TECH NOTE

Subject: Modified Outside Housing Requires New Lever

Models: All Mortise and Exit Trim (except narrow-style) Models

New Lever (left); Previous lever (right)

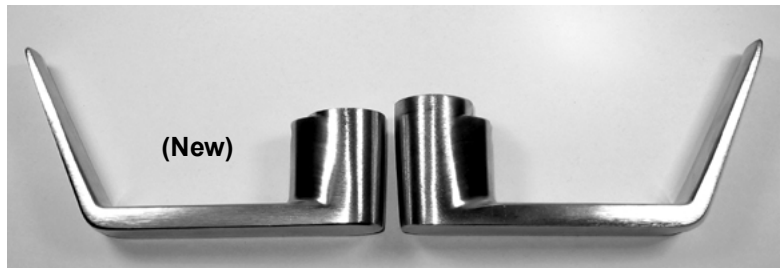
A design modification to the outside housing requires a shorter outside **Lever**, as the existing **Lever** will not fit into the modified outside housing. A new **Spindle Spacer** must also be used.

Therefore, when replacing the outside housing, ensure the new **Spindle Spacer** is fully inserted onto the spindle before attaching the new outside **Lever** (see photo below).

Spindle Spacer **MUST** be placed with "Recess" facing the spindle

Note: The new **Lever** is NOT interchangeable with previous **Levers**.
